ADDENDUM NO. 1

Date of Addendum: March 18, 2016

PROJECT NAME: Neighborhood Street Reconstruction Project No. 467

PROJECT NO: WBS No. N-000400-0001-4

WBS NUMBER
N-000400-0001-4
DRAWING SCALE
VERT. 1"=2' HORIZ. 1"=20'
CITY OF HOUSTON PM
BEN BANSAL, P.E.
SHEET No. 50 OF 226

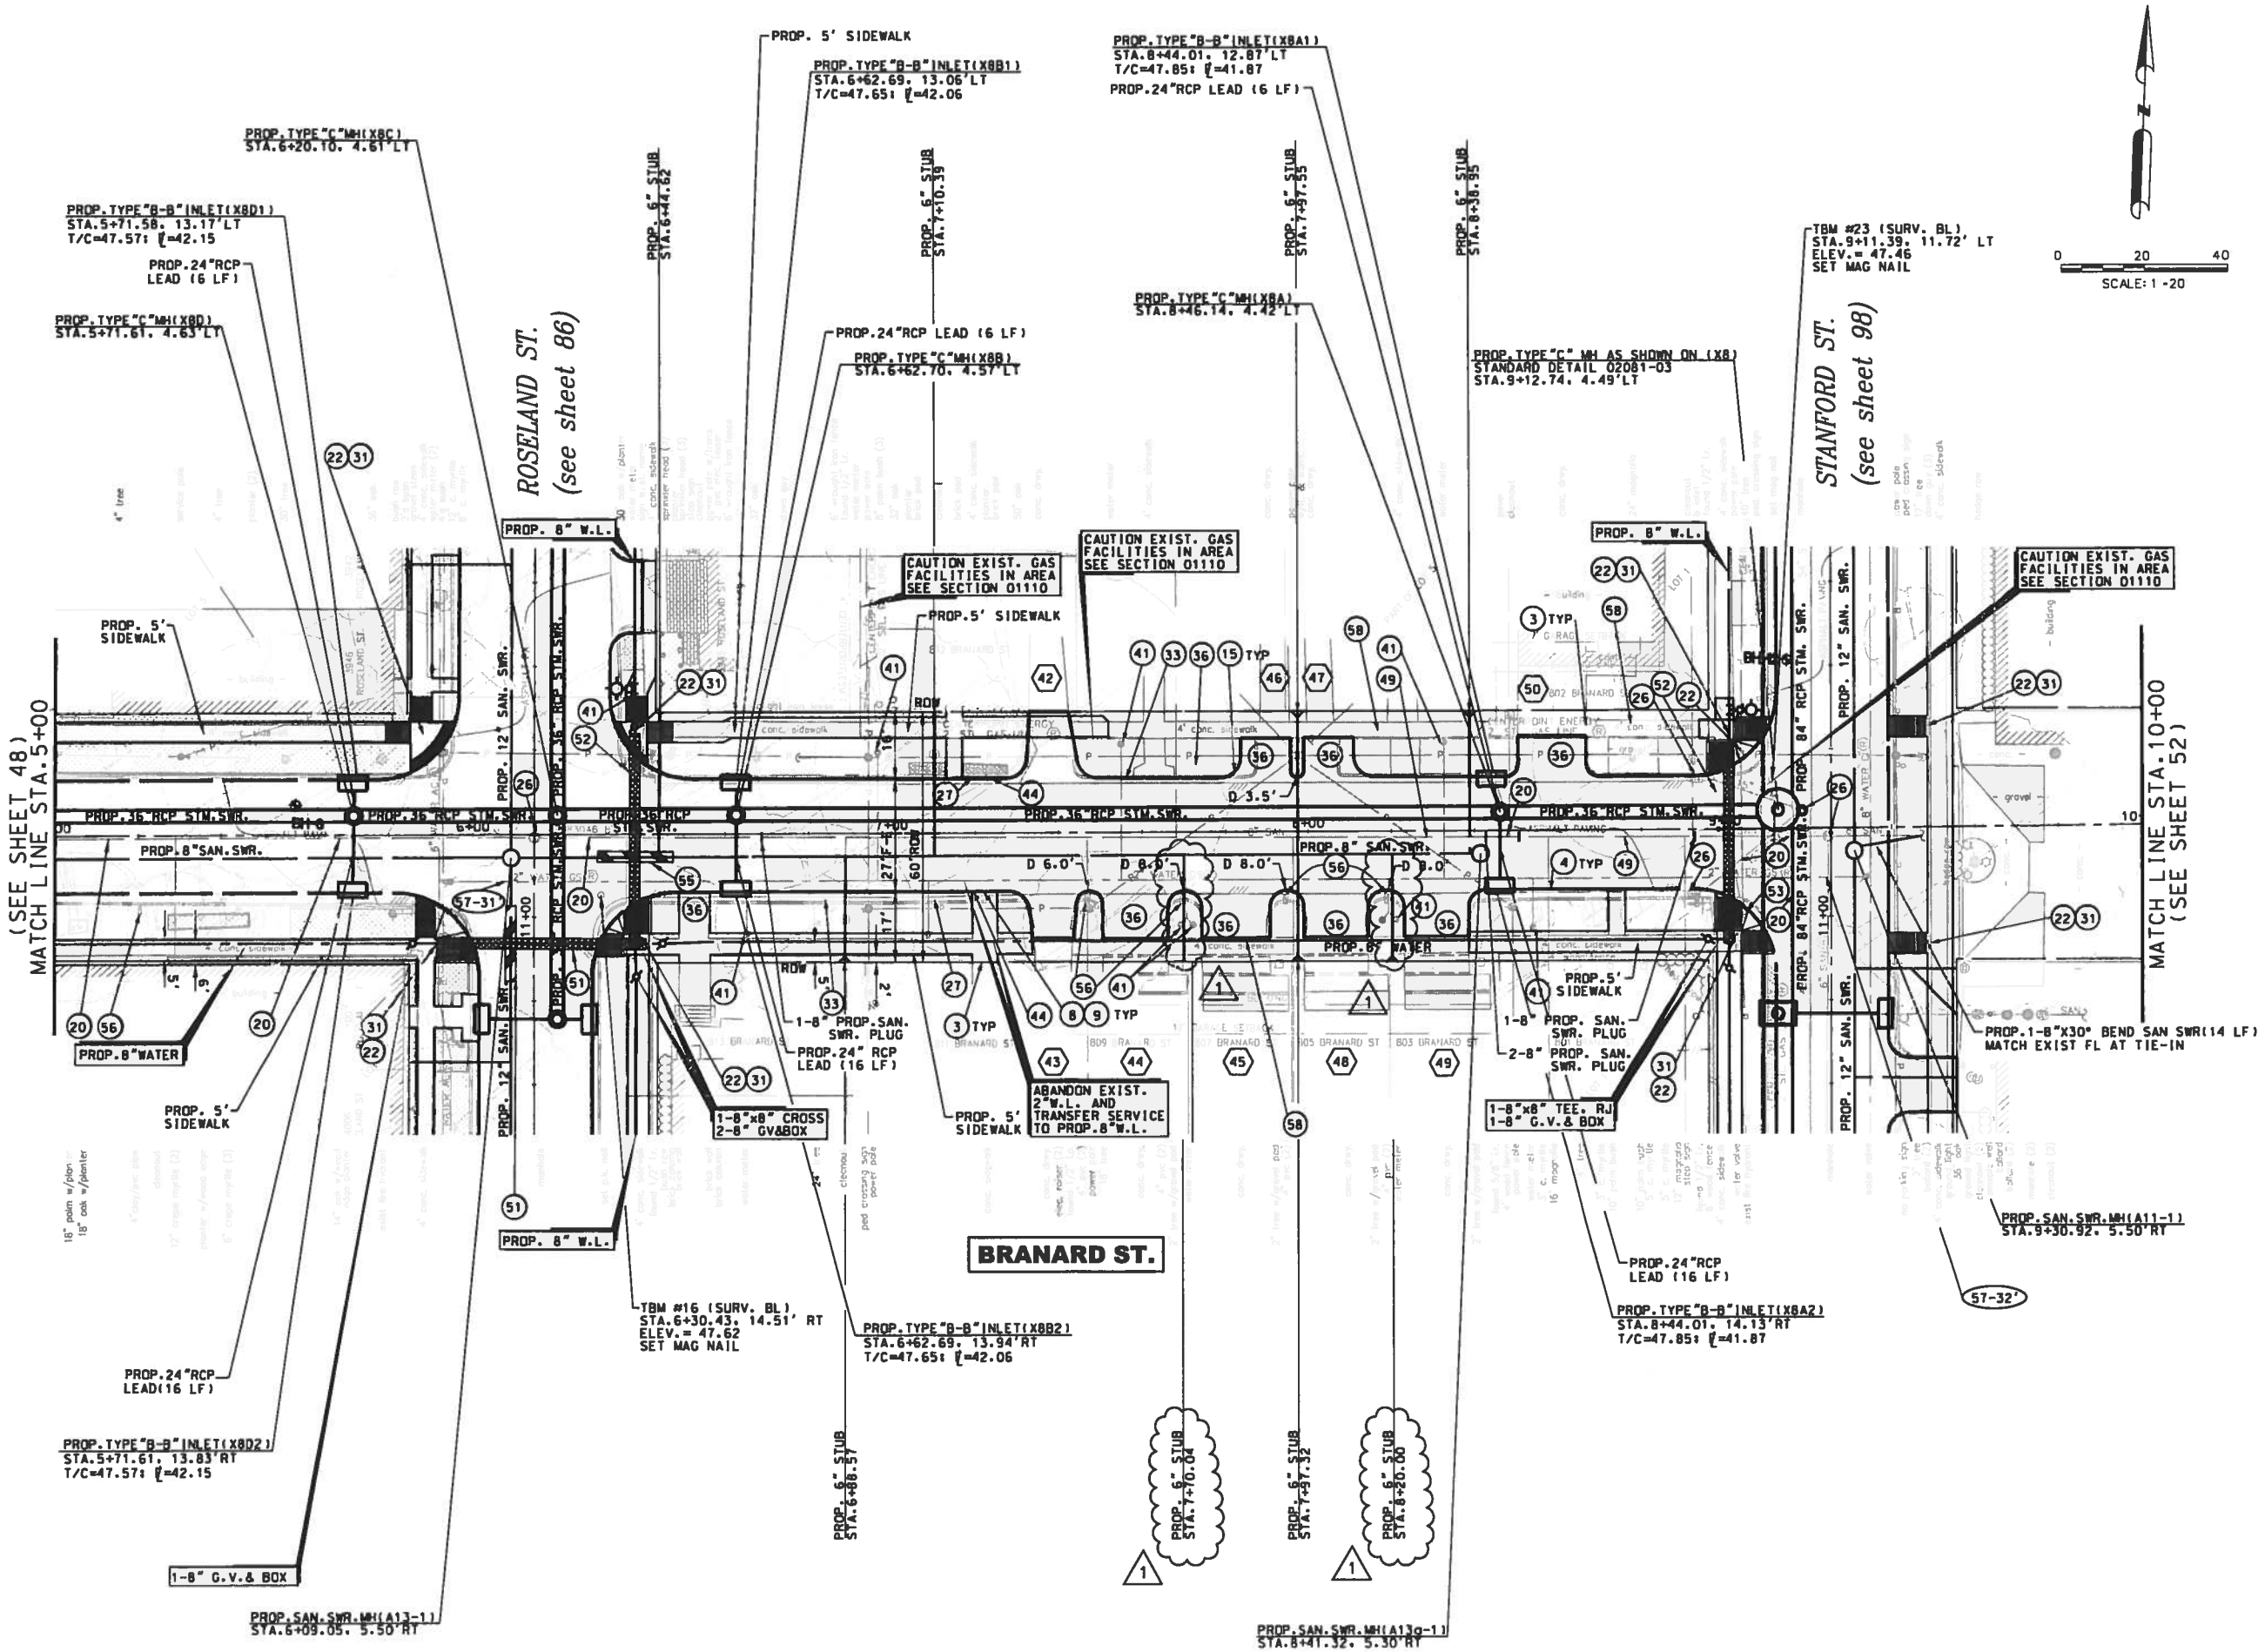
No.	DATE	REVISIONS	APP.
1	3/11	ADDENDUM #1 SERVICE STUBS REVISED	M.A.M.

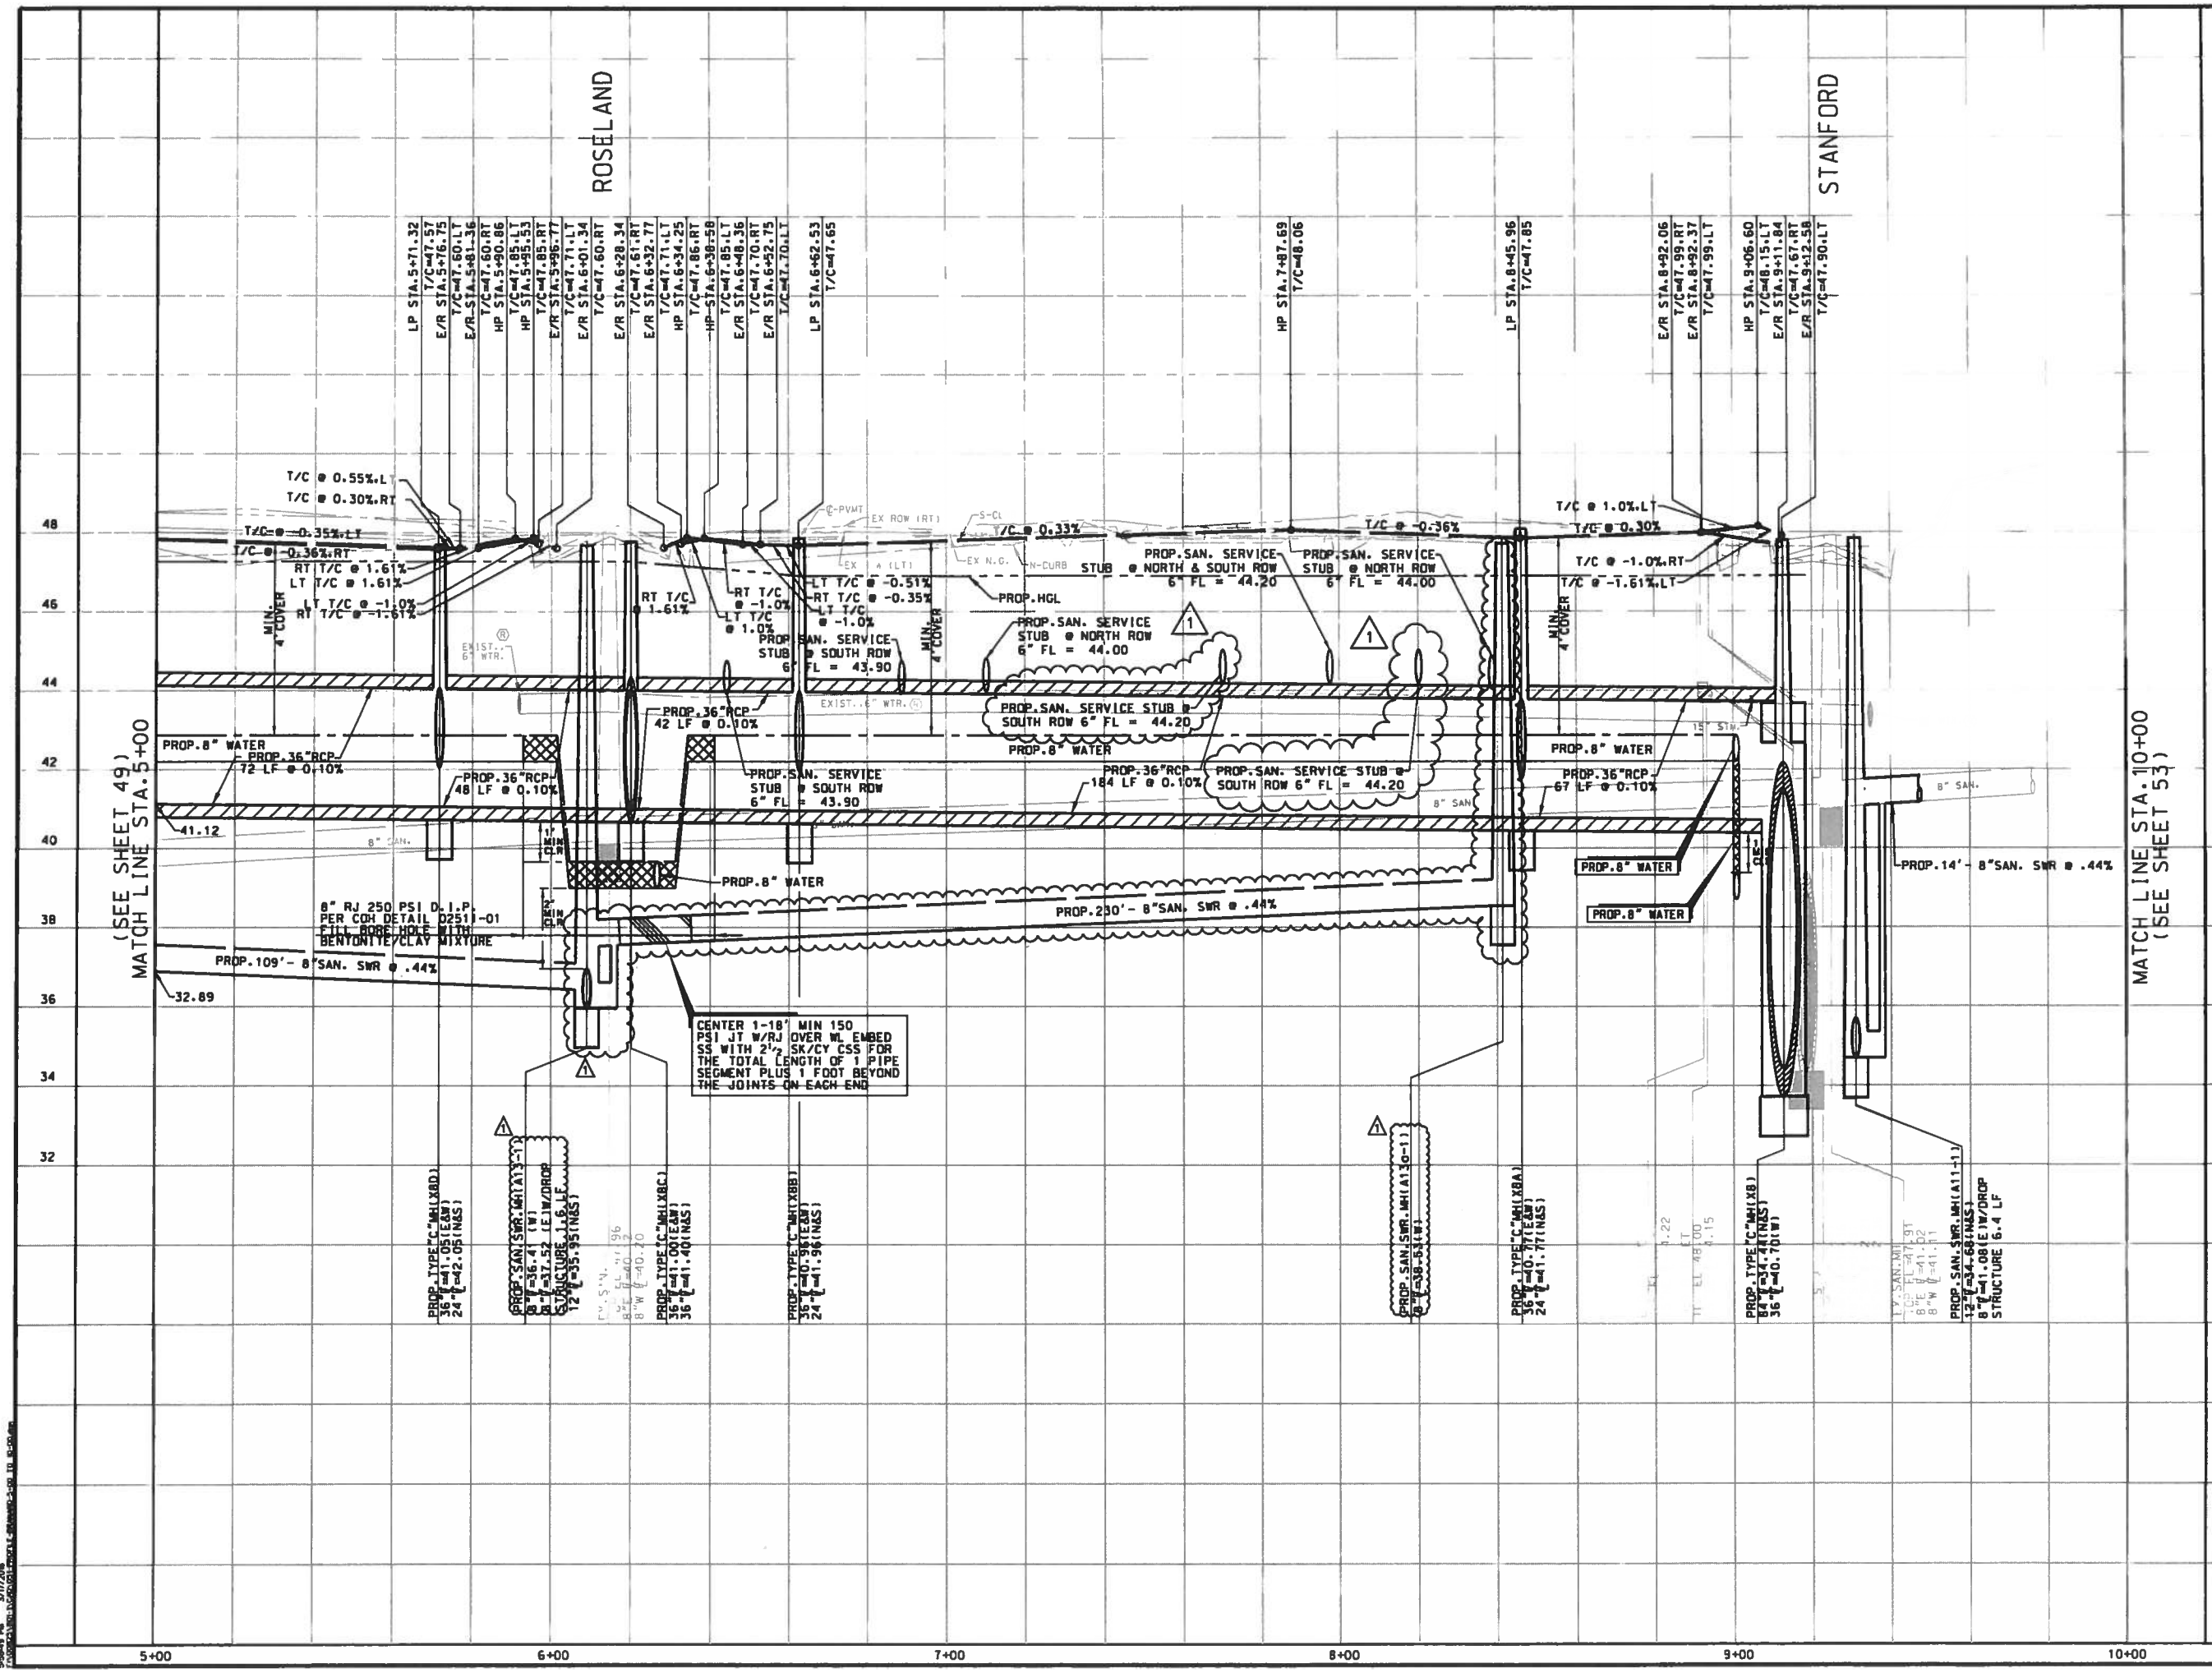
No.	DATE	REVISIONS	APP.
1	3/11	ADDENDUM #1 SAN.SWR. & SERVICE STUB REVISED	M.A.M.
